LEAHI HOSPITAL
HAWAII HEALTH SYSTEMS CORPORATION

SUBJECT: Addendum No. 1
IFB No. 23L-0421 Leahi Hospital Renovation of Adult Day Health

INVITATION FOR BIDS
for
LEAHI HOSPITAL
RENOVATION OF ADULT DAY HEALTH
3675 Kilauea Ave., Honolulu, HI 96816

ADDENDUM NO. 1

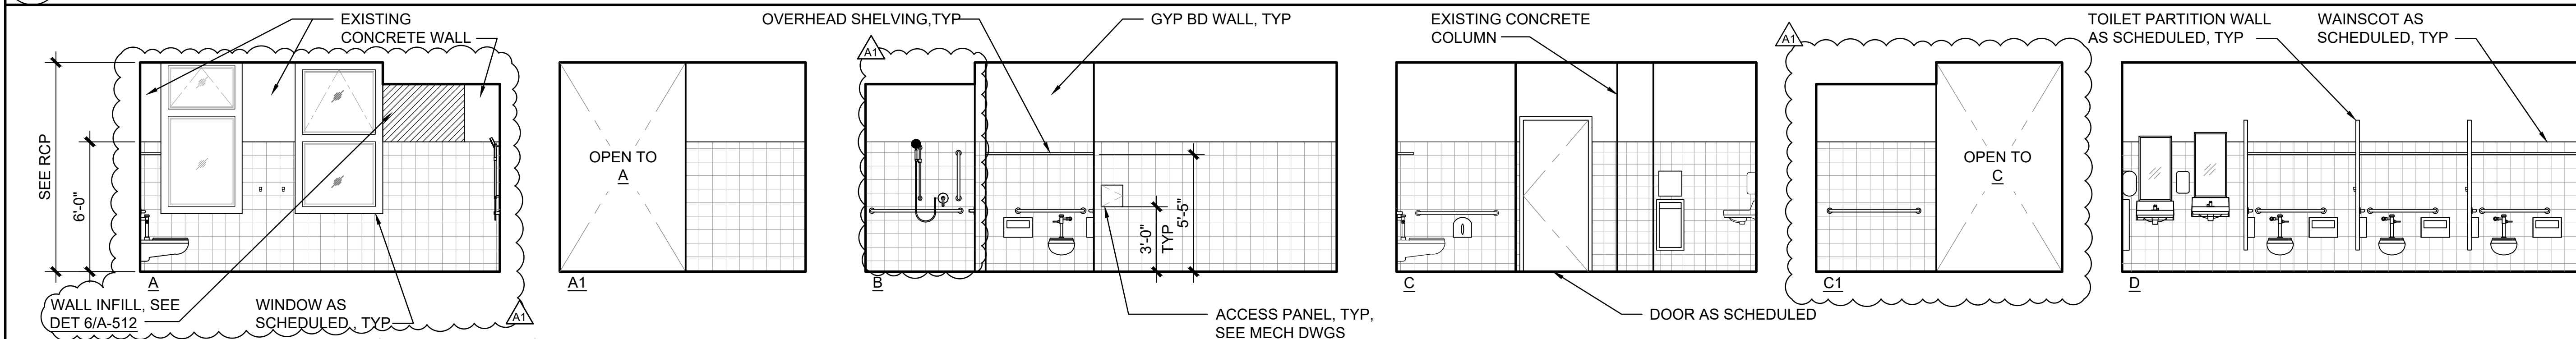
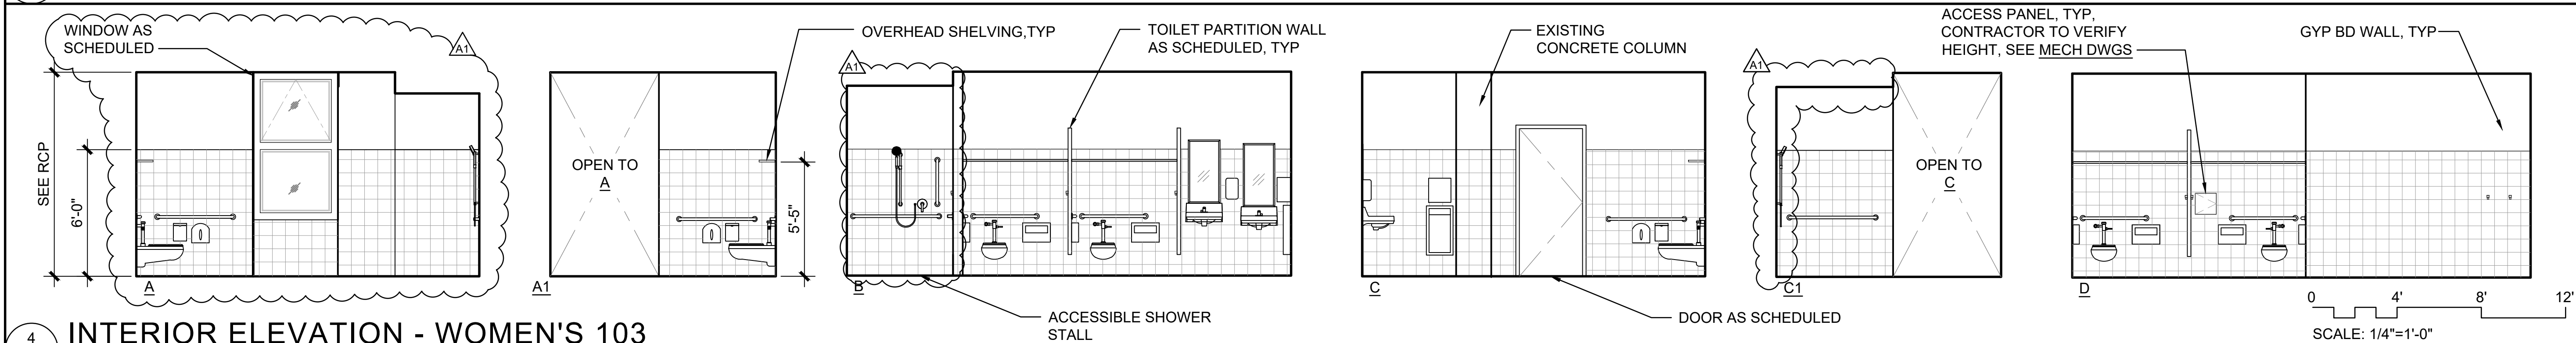
1. Question: Plan A-201 shows window infill at Conference room 101 & Men's 102. Please advise what material we need to use for the window infill/ if there is any detail to follow.

2. Question: Plan A-201 shows a wall infill at women's 103. Please advise what material we need to use for the window infill/ if there is any detail to follow.

Answer: Details have been added to the drawings for wall infills.

Answer: Details have been added to the drawings for wall infills.

2 **SHOWER THRESHOLD DETAIL**
A-512 SCALE: 3" = 1'-0"

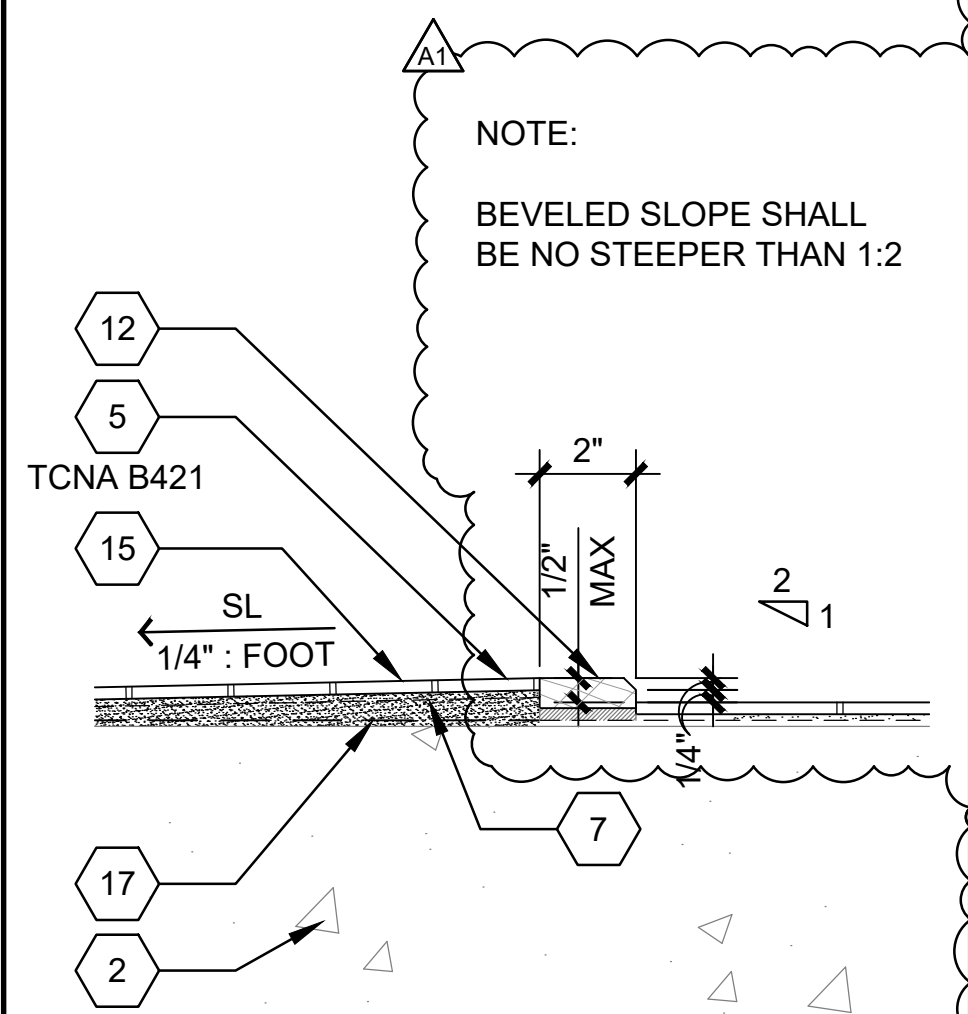
10. Question: In regard to Q9, there is another marble threshold for the shower, can you please clarify size of that on as well?

Answer: Shower to have 2" marble threshold.

DOOR DETAIL - THRESHOLD

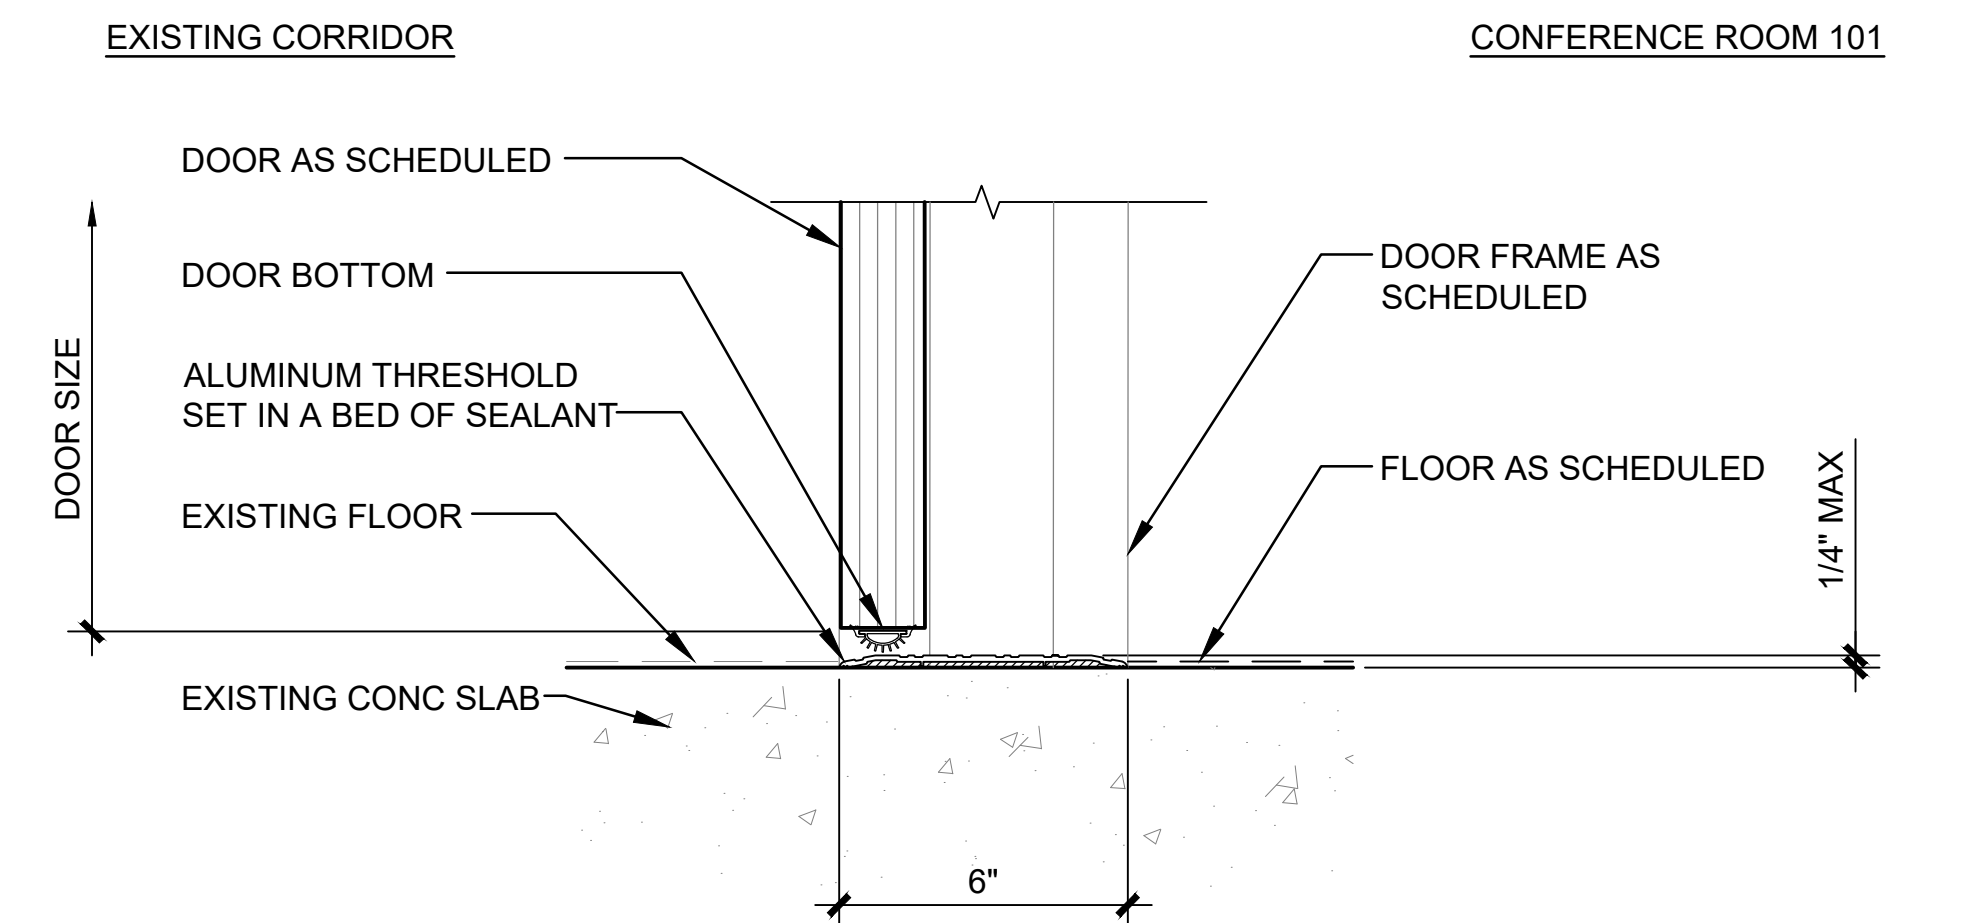
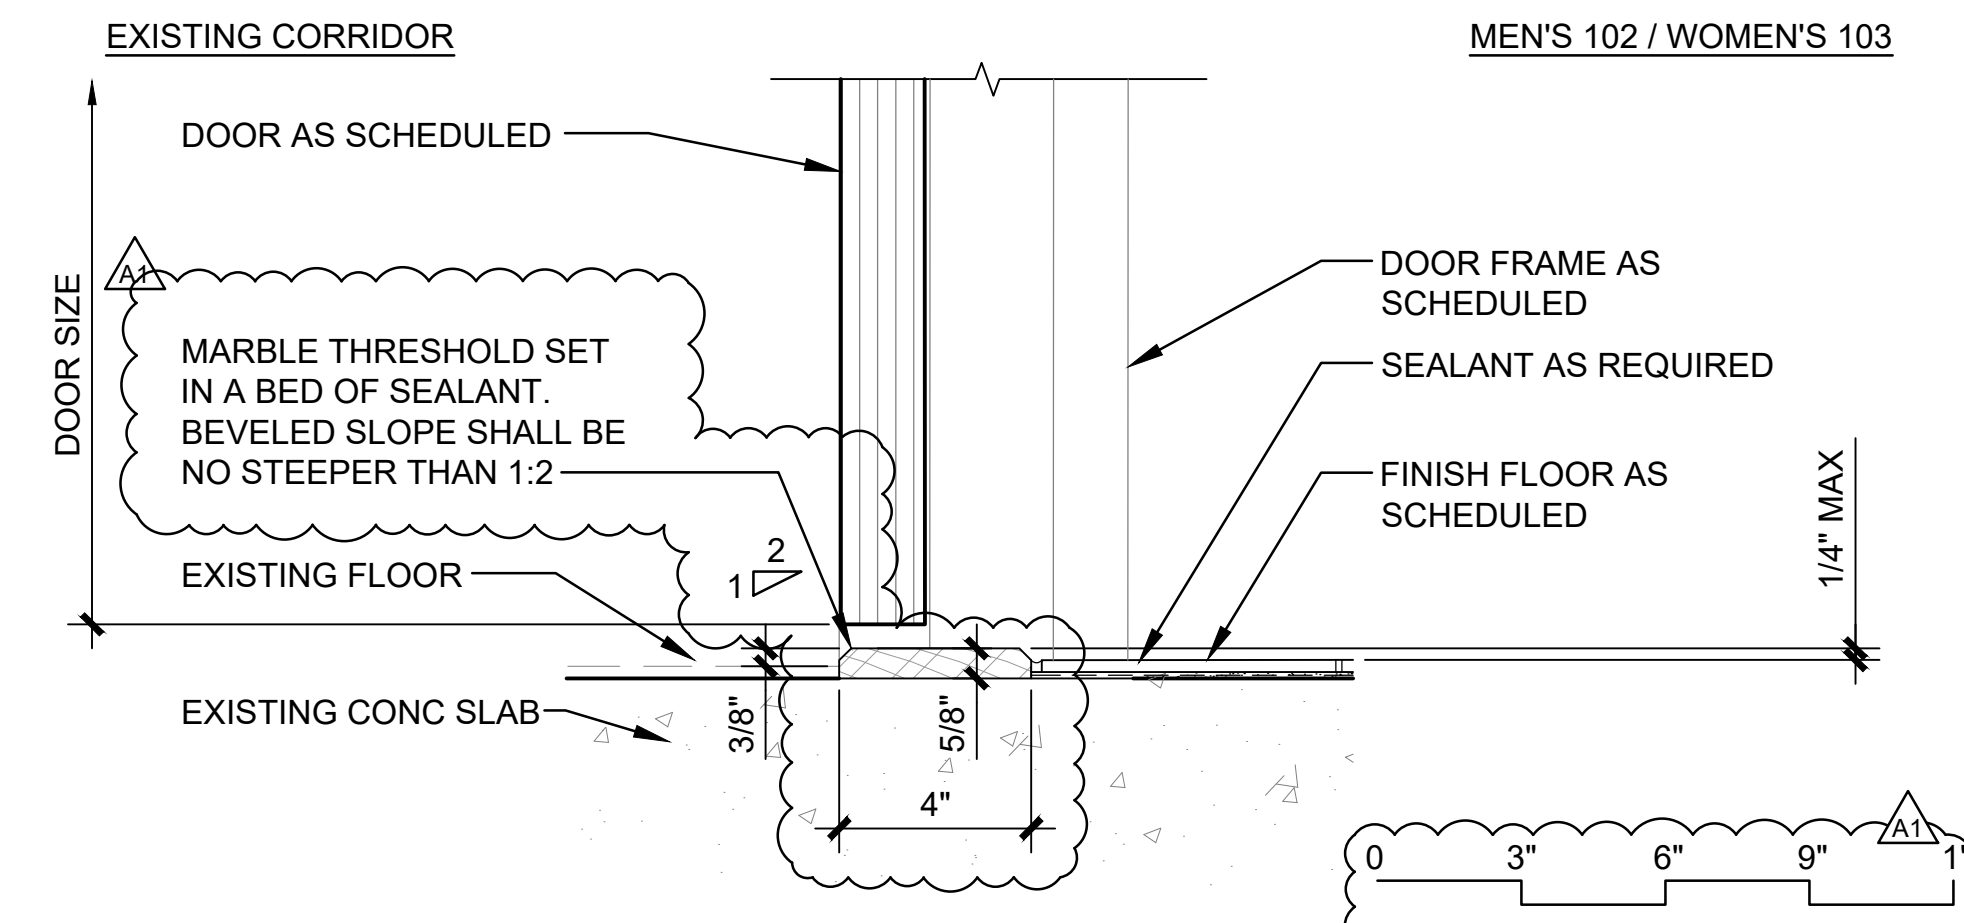
9. Question: Specs state a 2" marble threshold, but on the plan details, the threshold is wider than 2". Please clarify.

Answer: Entry door to have 4" marble threshold.

Sheet Title:
MECHANICAL SCHEDULE

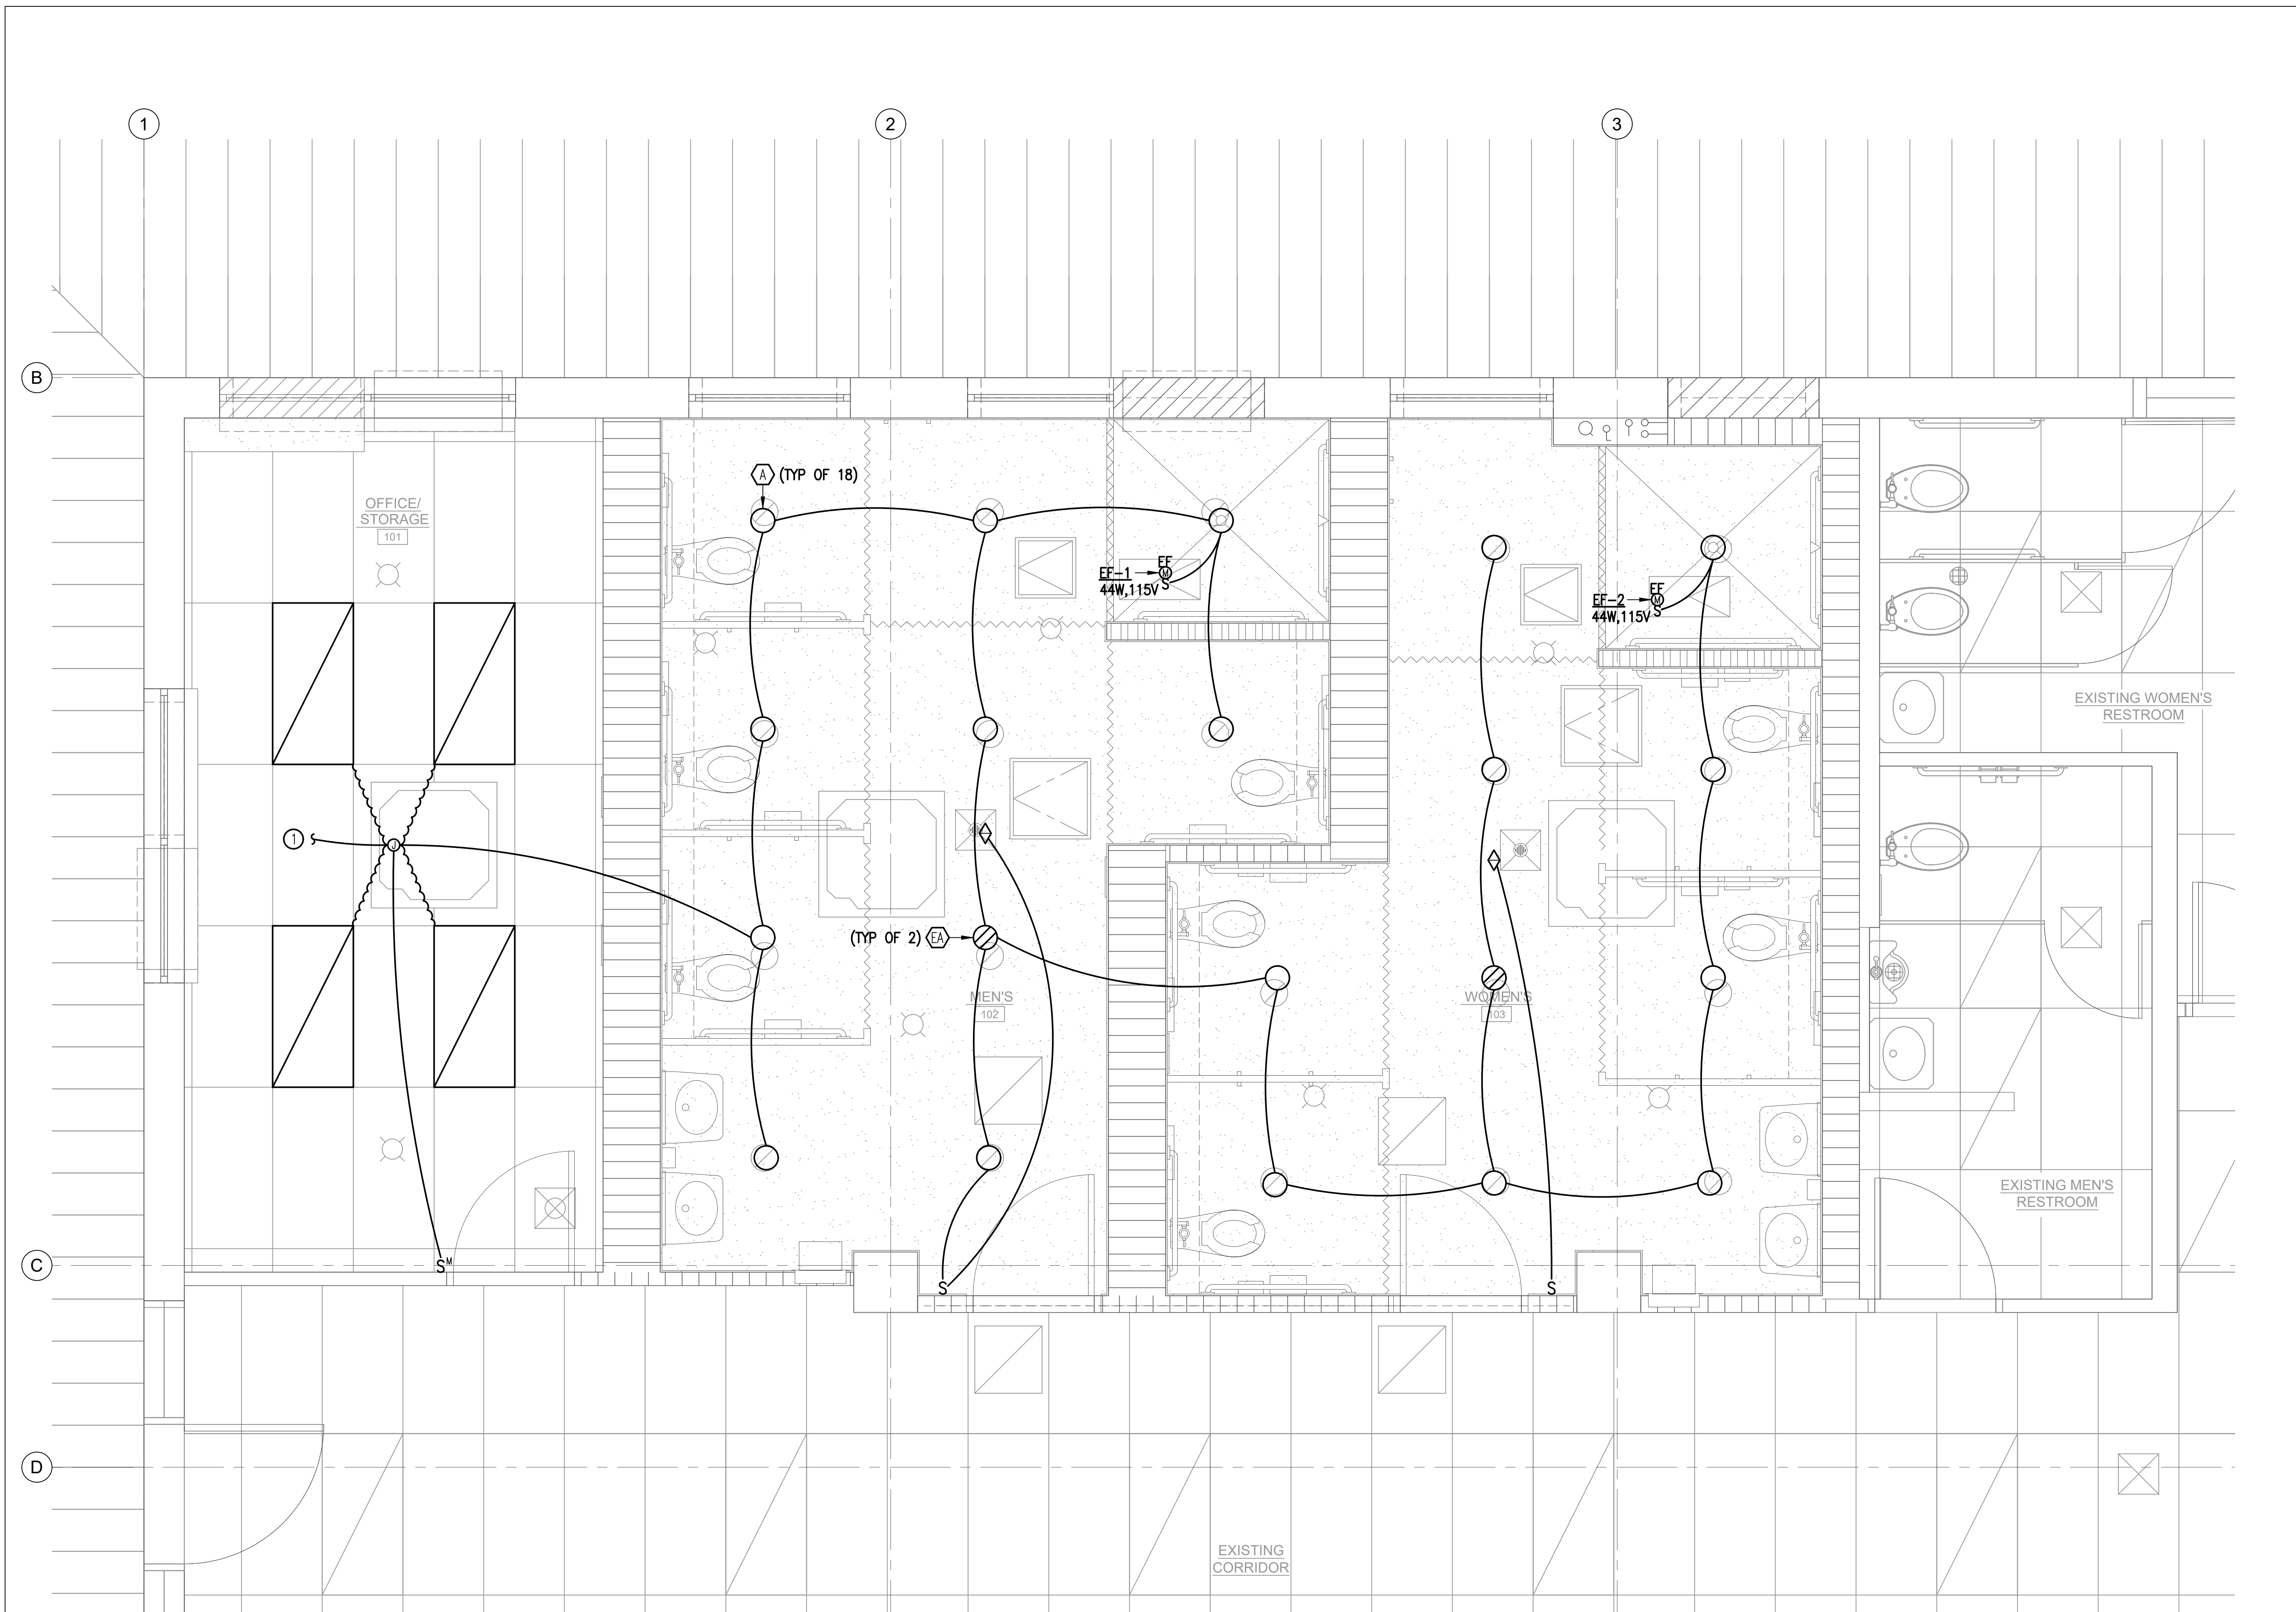
7. Question: The remarks for the FCUs on sheet M-109 say to provide isolation mounts. However, the supplier says that Mitsubishi does not recommend isolation mounts and will not supply them. Can the requirement for isolation mounts be removed.

Answer: We defer to the manufacturer's recommendation and take no exception if not requiring isolation mounts for FCU.s
